Product Change Notification

BOURNS® PRODUCTS

Barcode Production Labels Will Change from 1D to 2D Barcode Format Over Time

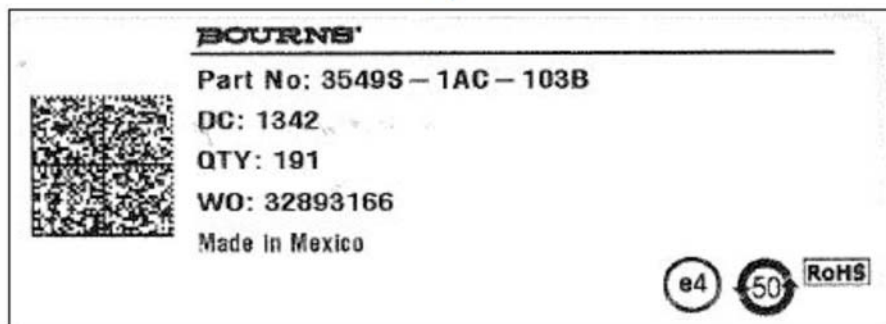
In the spirit of continuous improvement, Bourns' standard production labels will transition from a 1D (one-dimensional) to a 2D (two-dimensional) barcode format using the Data Matrix 2D barcode format. The primary reason for making this change is to be able to capture and track more information related to the manufacture of the product than is currently captured using the 1D label format.

The current 1D barcode format captures the part number, quantity, and date code information. The 2D barcode format will capture the part number, quantity, date code, lot code, work order and purchase order information which enables greater traceability regarding the manufacturing of Bourns® products.

This change is a label change only and will have no effect on the form, fit or function of the Bourns® products themselves. The marking/labels affixed to the products will differ from the current 1D format.
